ADDENDUM #1

March 5, 2025

RE: MILAN HOUSING RENOVATION

The following items are clarifications, additions or modifications to the Bid Documents.

TTL

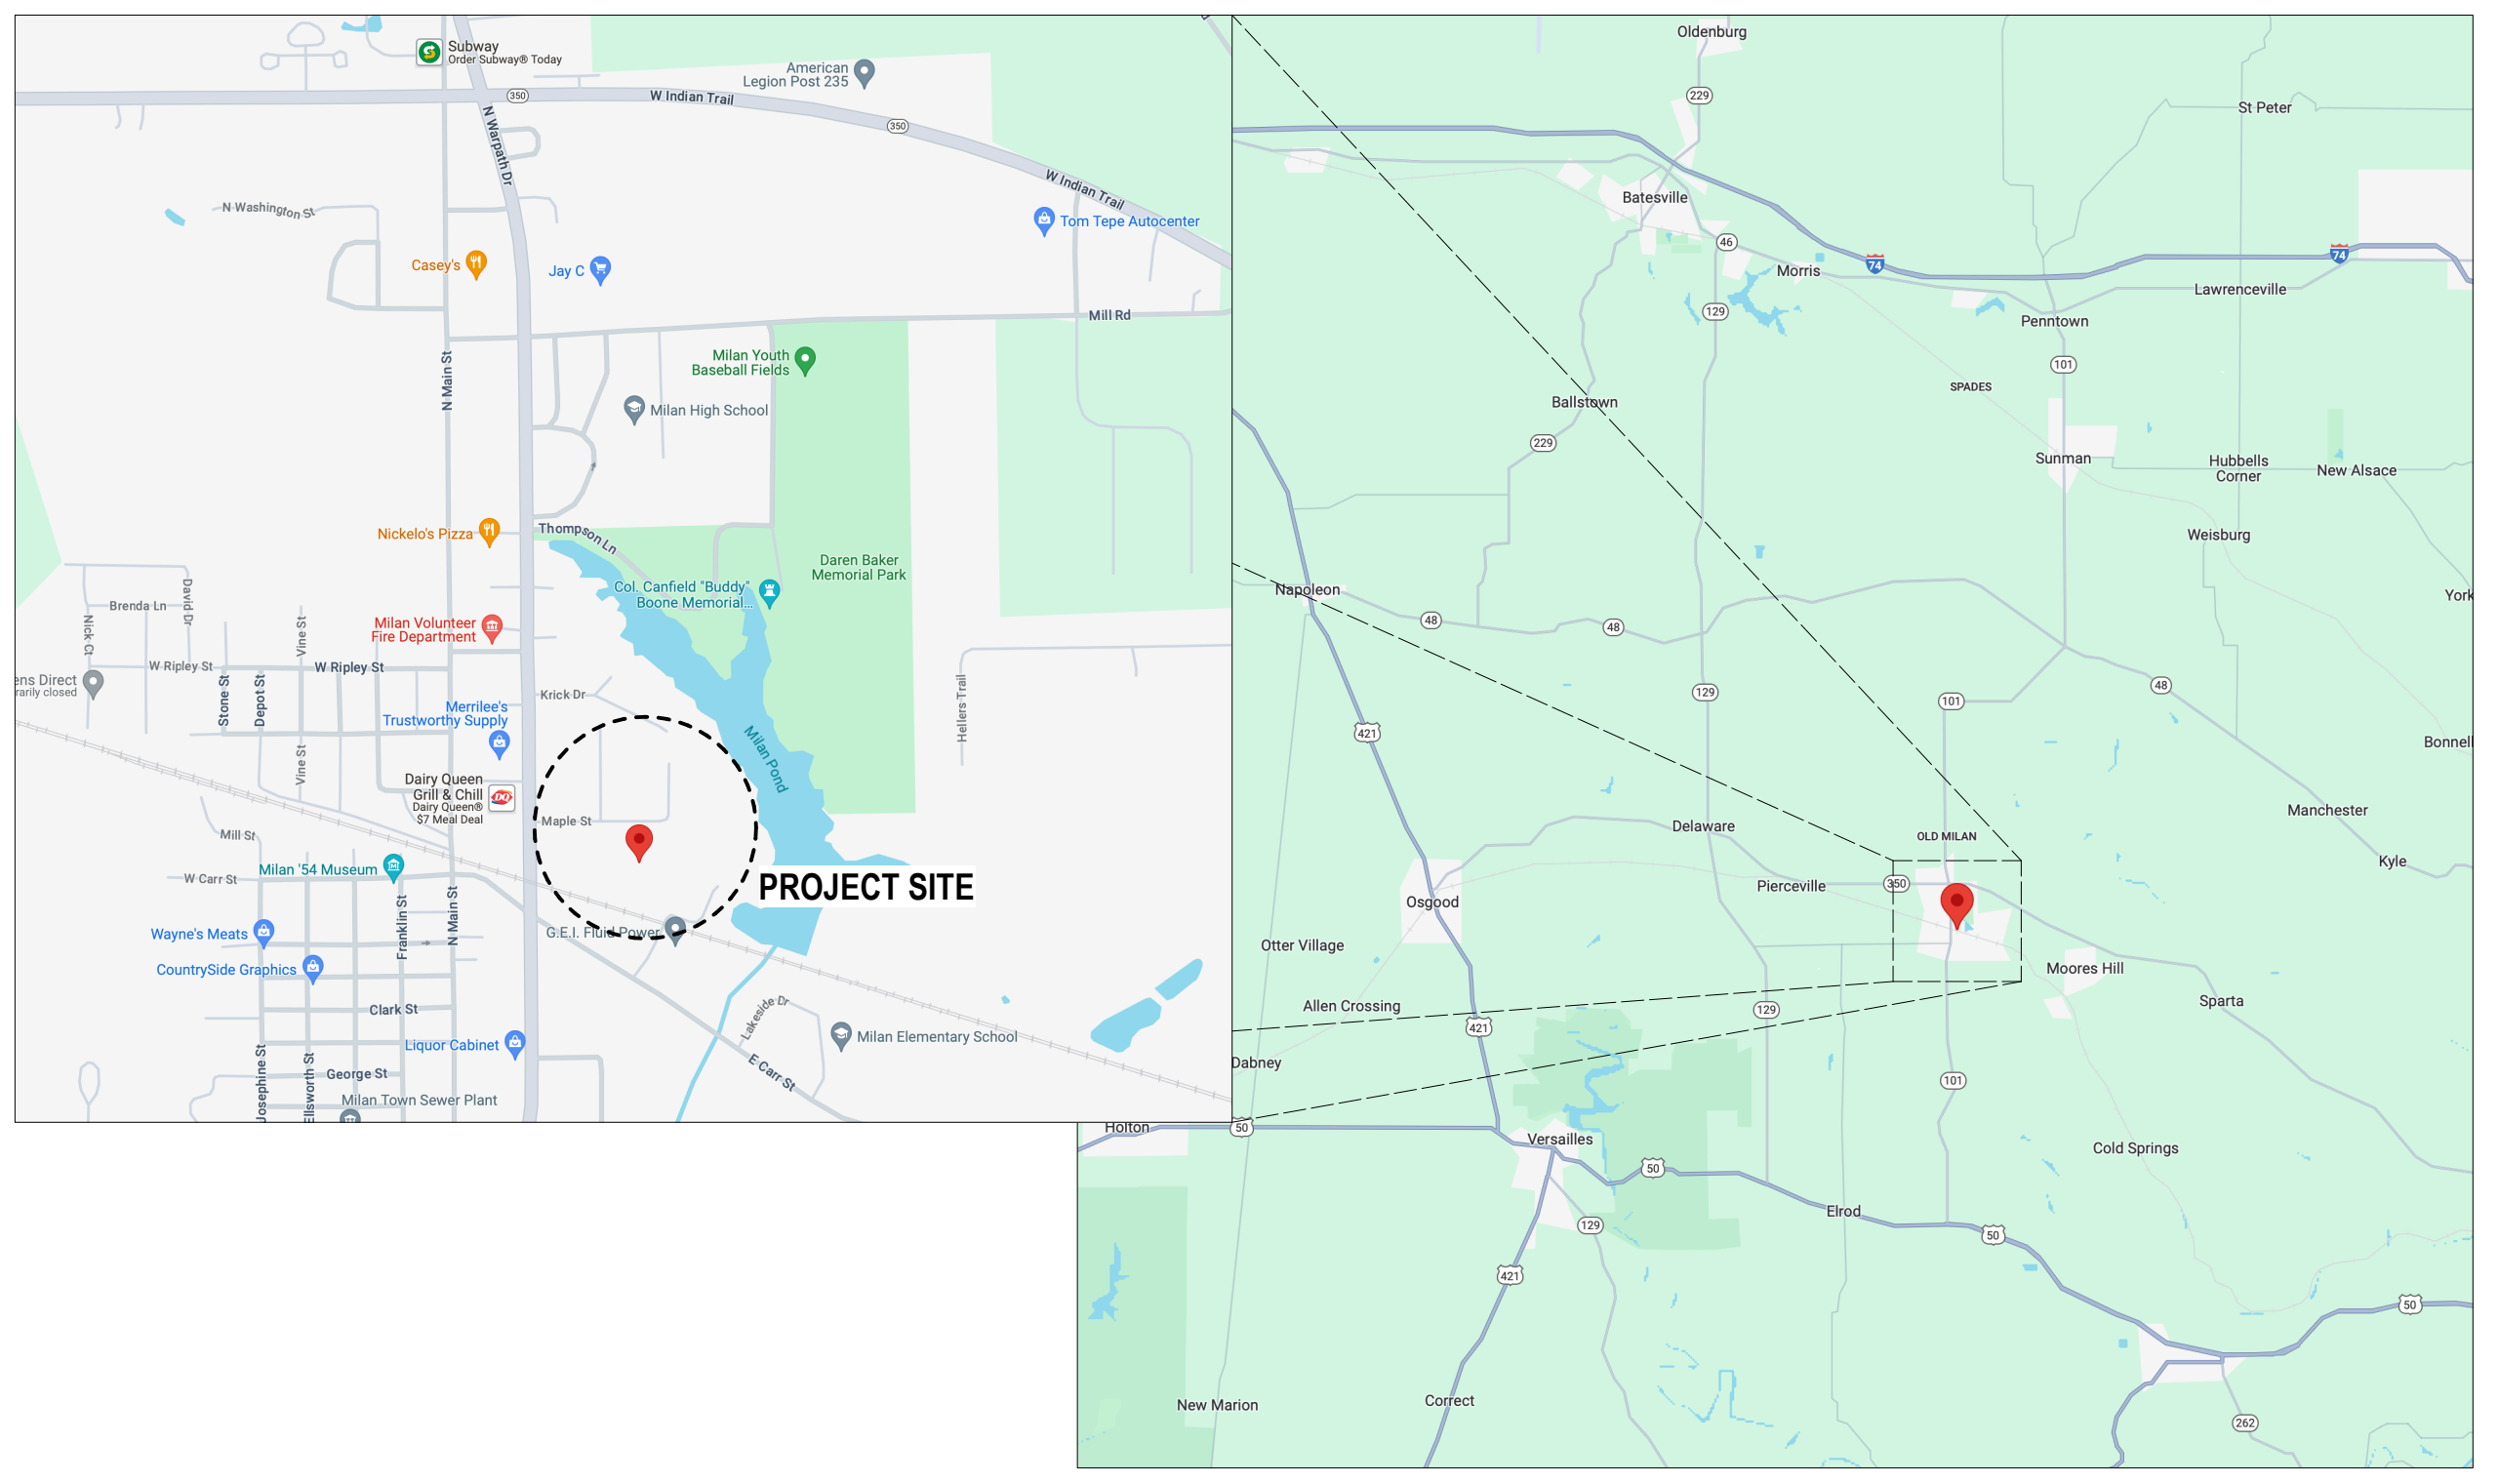
1. **Sheet TTL:**
A. Add Alternate #15: Balcony Structure and Railings to Alternate Bids list.
2. **Sheet SP1:**
A. Additional bench location noted and clouded.
3. **Sheet A3.0:**
A. Revised plumbing schedule fixture SH2 to Model AM TU662.215

Sheet Title	Site Plan
-------------	-----------

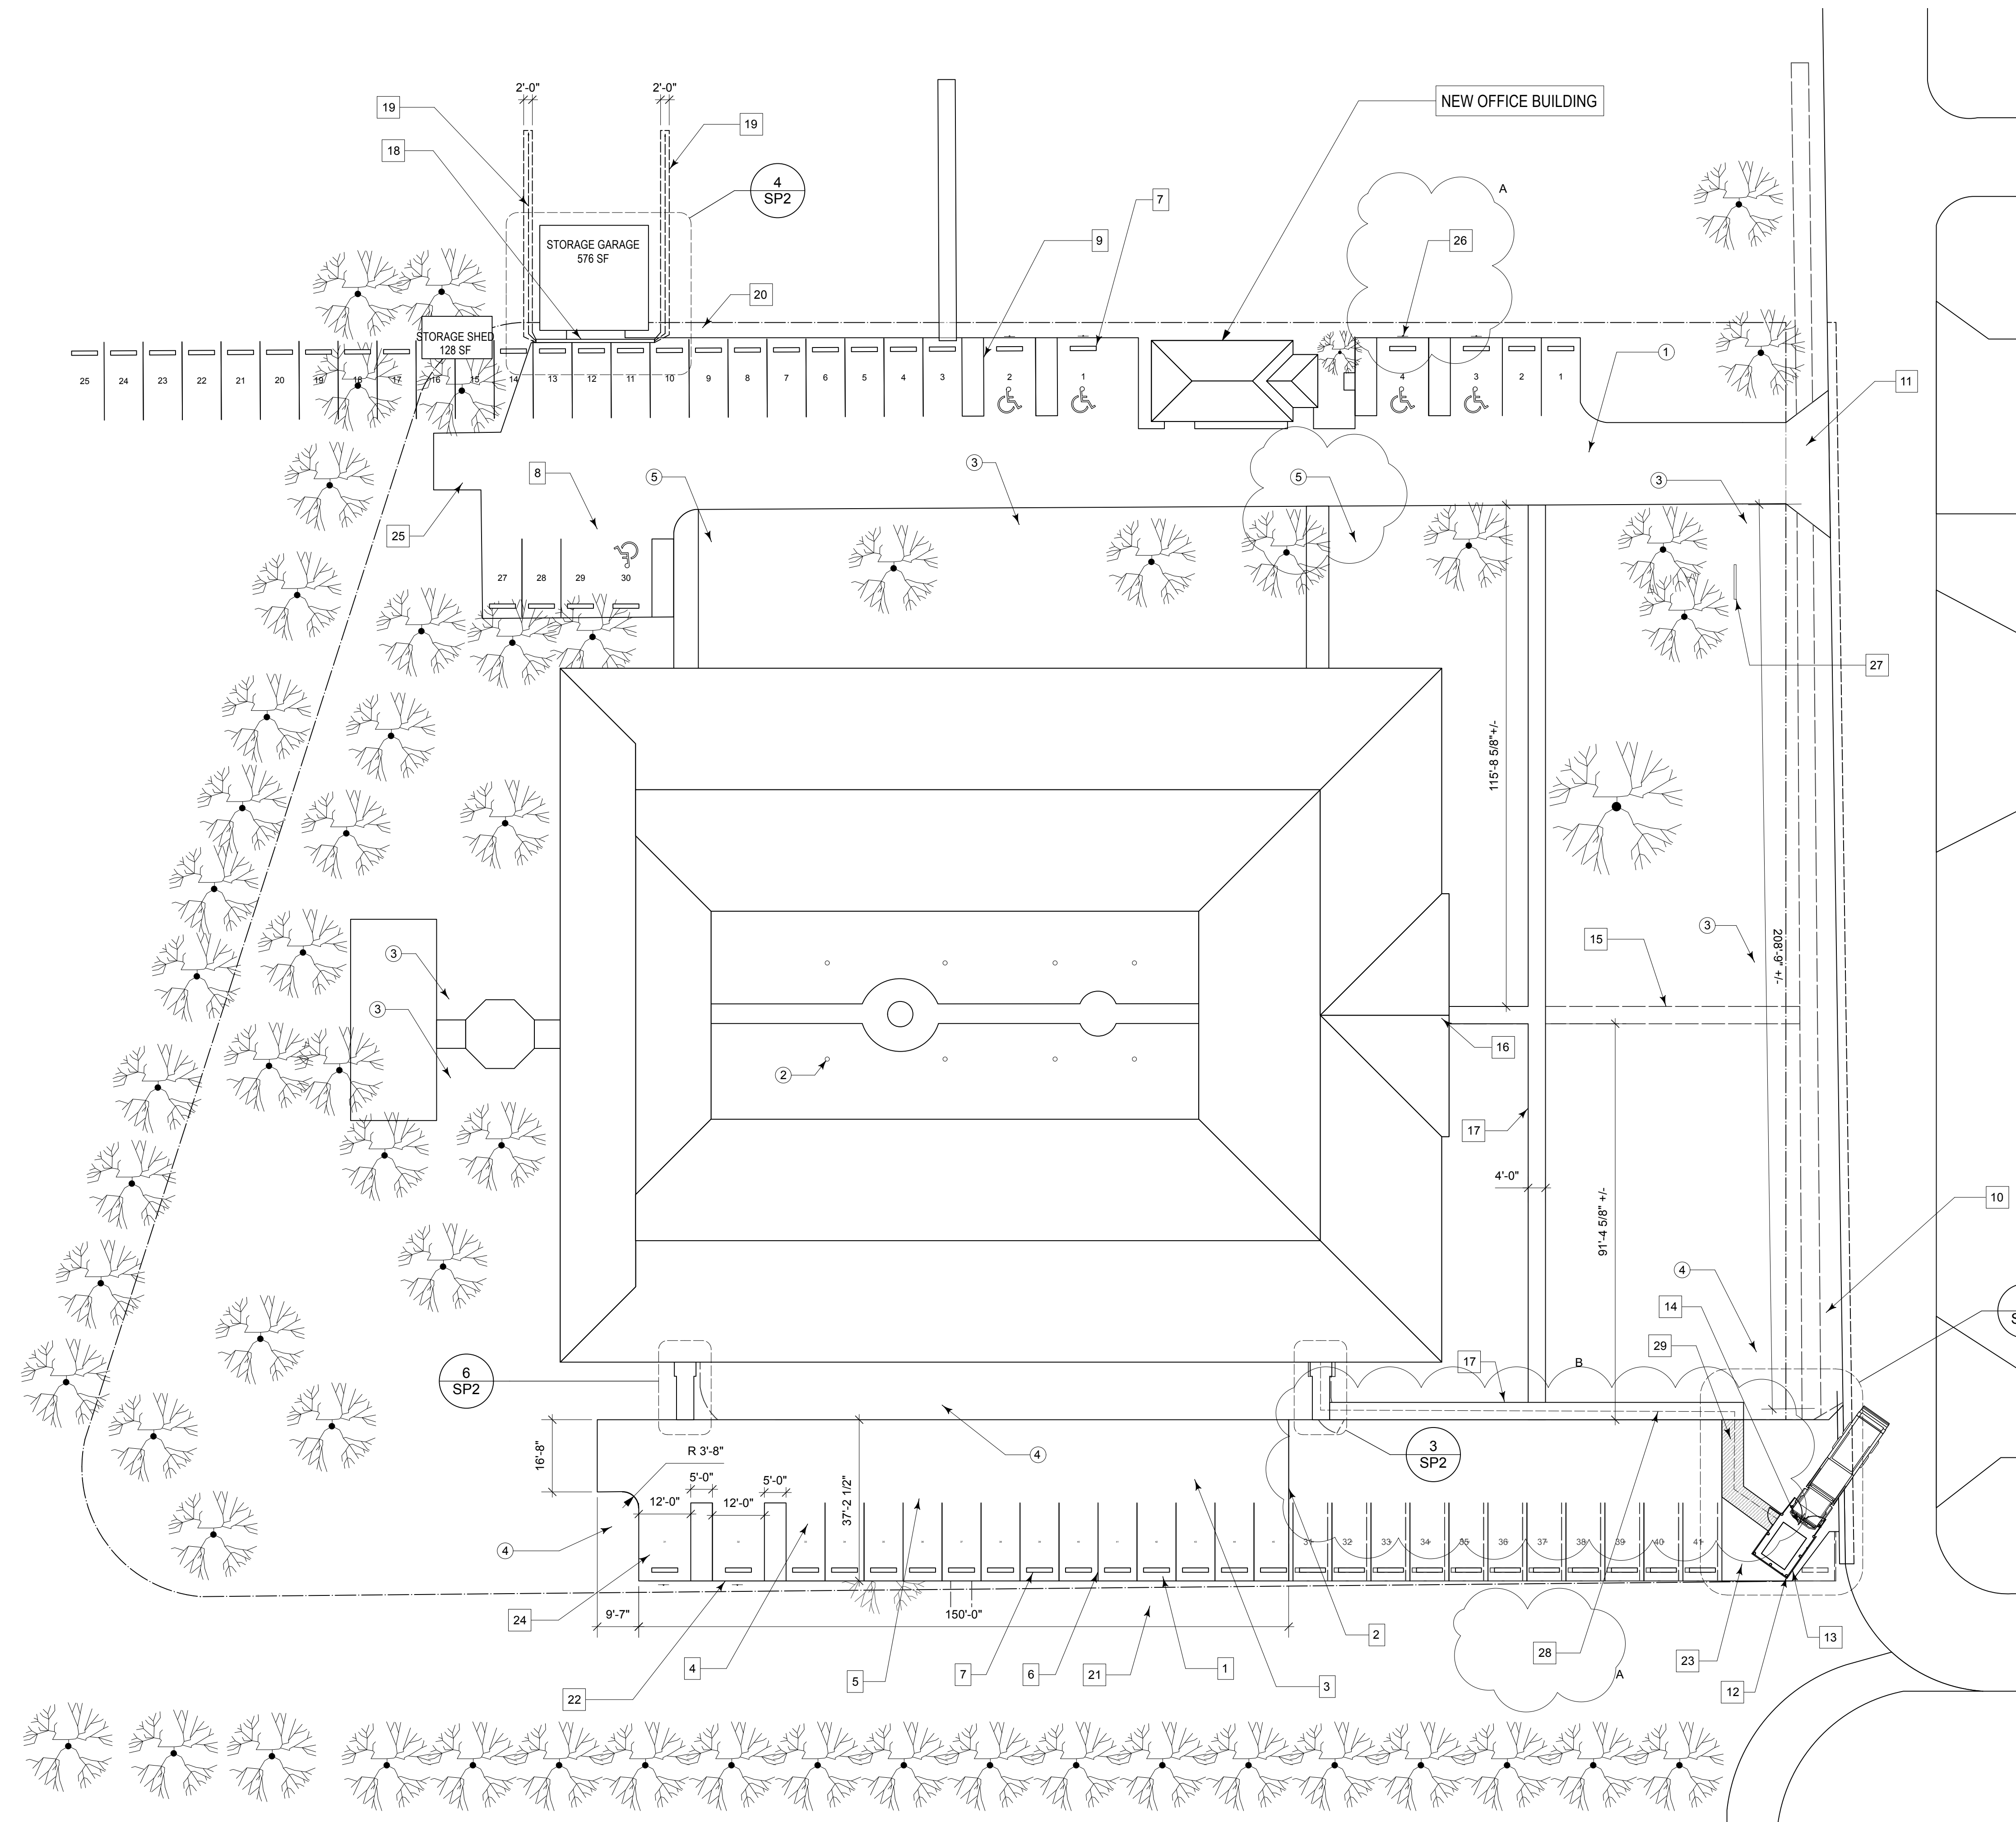
A. No, the building has not been tested, and, to date no agency has requested testing. See general note on sheet TTL for more information.
7. Clarification: Sheet SP1 Note 5 calls for an alternate price to replace the wood on the exterior bench. The notes should refer to benches. There are two benches included in this alternate price.

8. Q: what type of wire has been used in the building.
A. It is assumed be romex type.
9. Q: Note 1 on SP1 appears to be pointing at a parking bumper but the note refers to tree and stump removal, please clarify.

A. The note is pointing to the approximate location of a tree (stump) that is existing and should be removed.
10. Q: Note 4 on SP2 call out wood to be replaced. Is this wood on the inside or outside.

A3.0

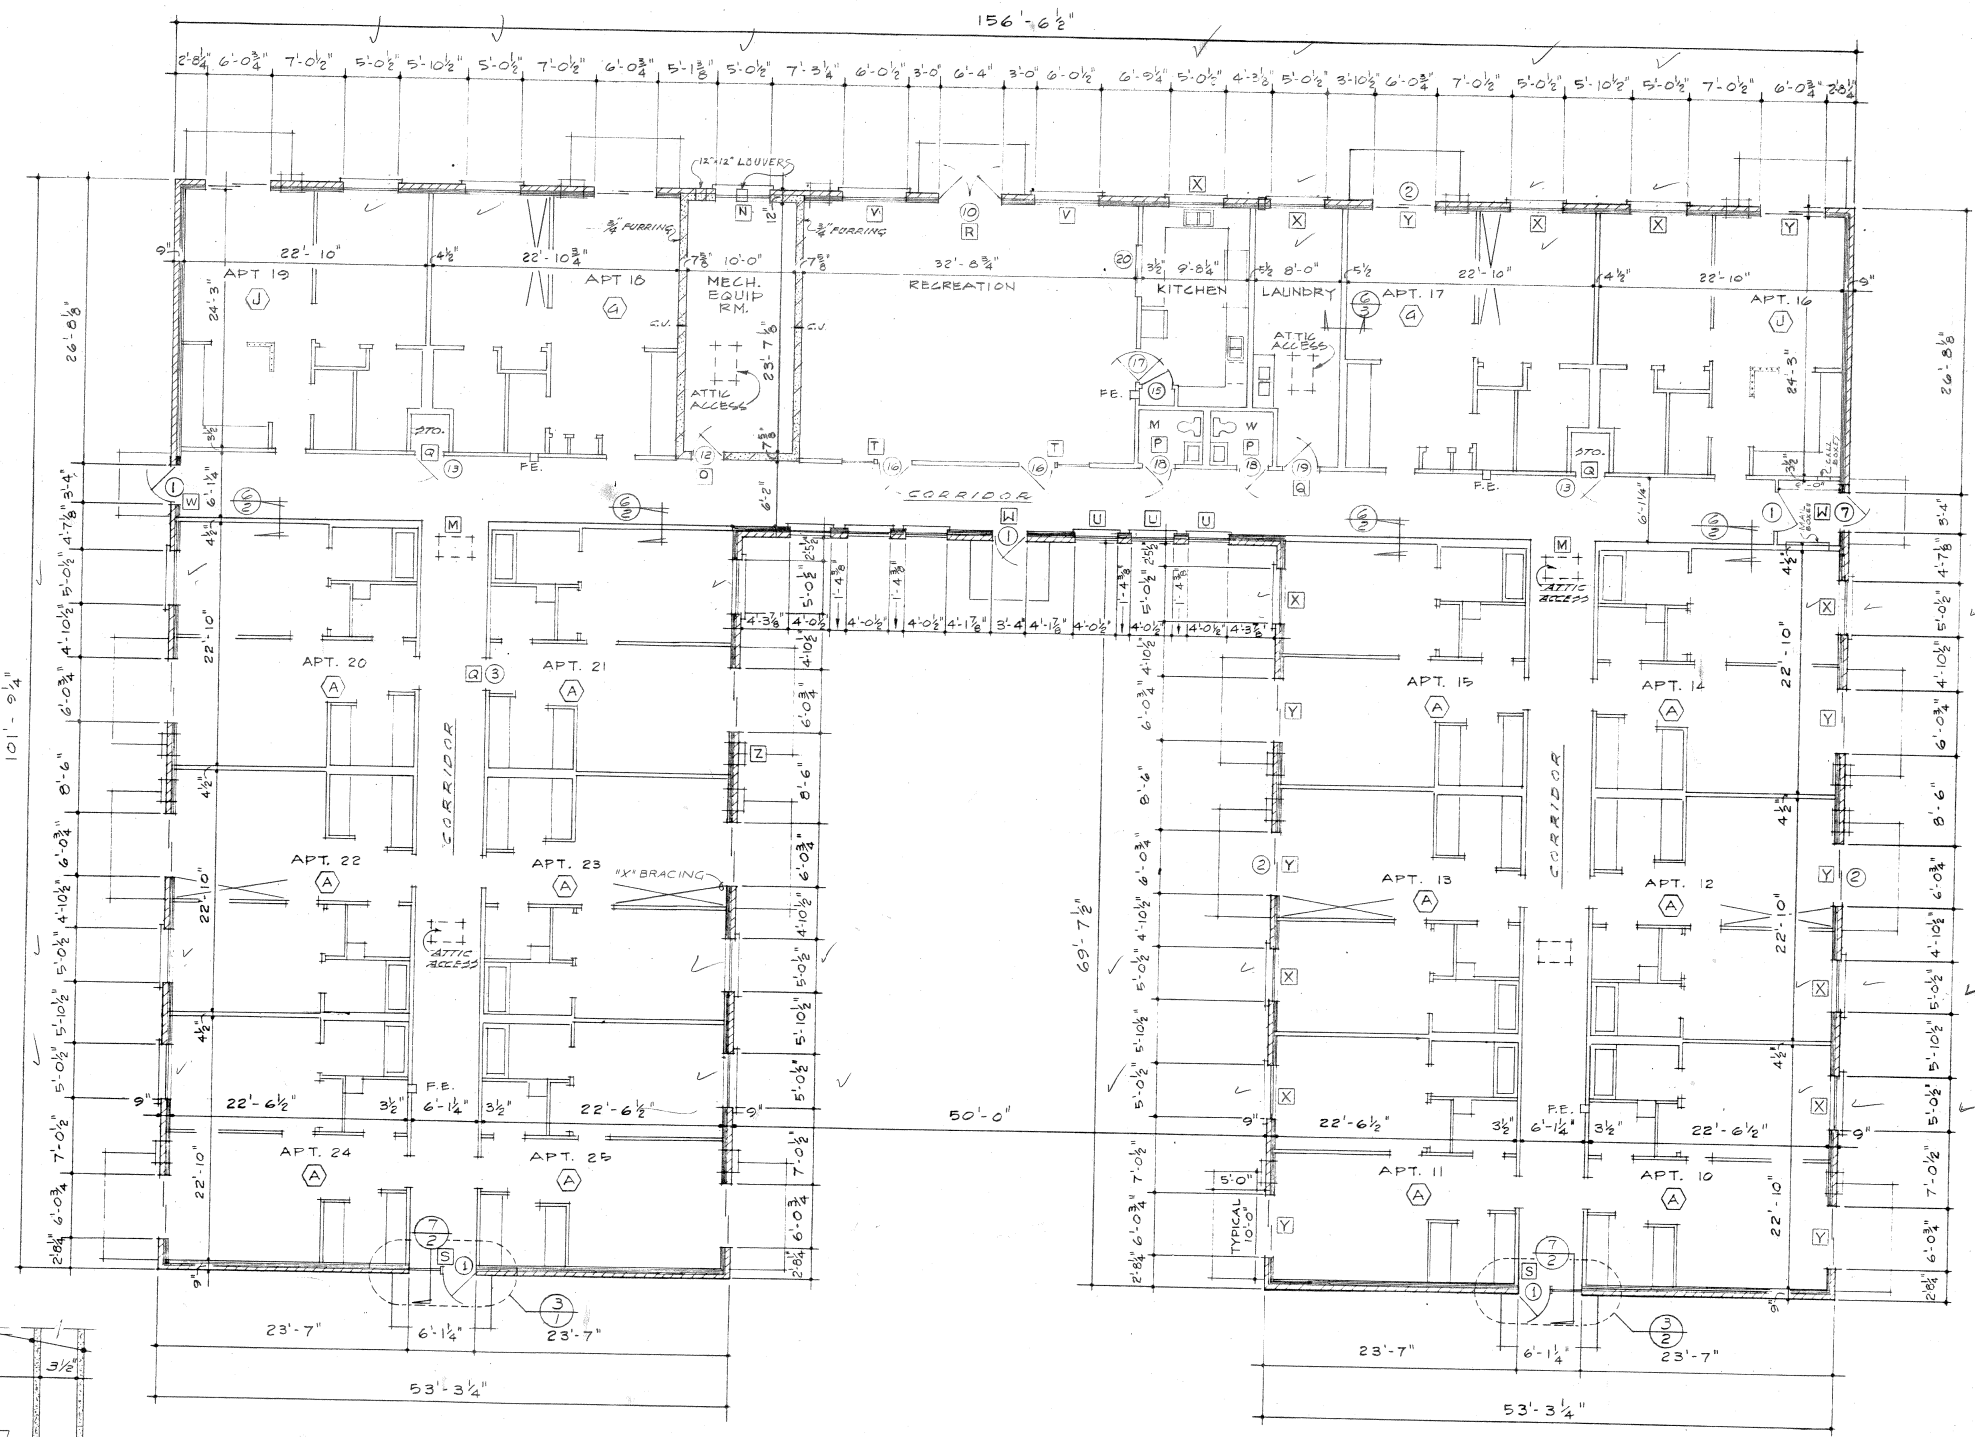
11. Q: Is this project tax exempt?
A. No. All applicable taxes must be paid by the contractors.
12. Q: Fixture SP2 calls for tub spout in certain units but the shower valve that has been identified does not have a tub spout option. What fixture should replace SP2?

A. American Standard TU662.215.
13. Q: Note 1 - Unit Prices on sheet A3.0 calls for a unit price per sheet of roof deck replacement. Are the roof deck repairs to be counted by the square foot or by instance.

A. By instance. It should be assumed that each are of damaged roof deck is at least one sheet of decking.
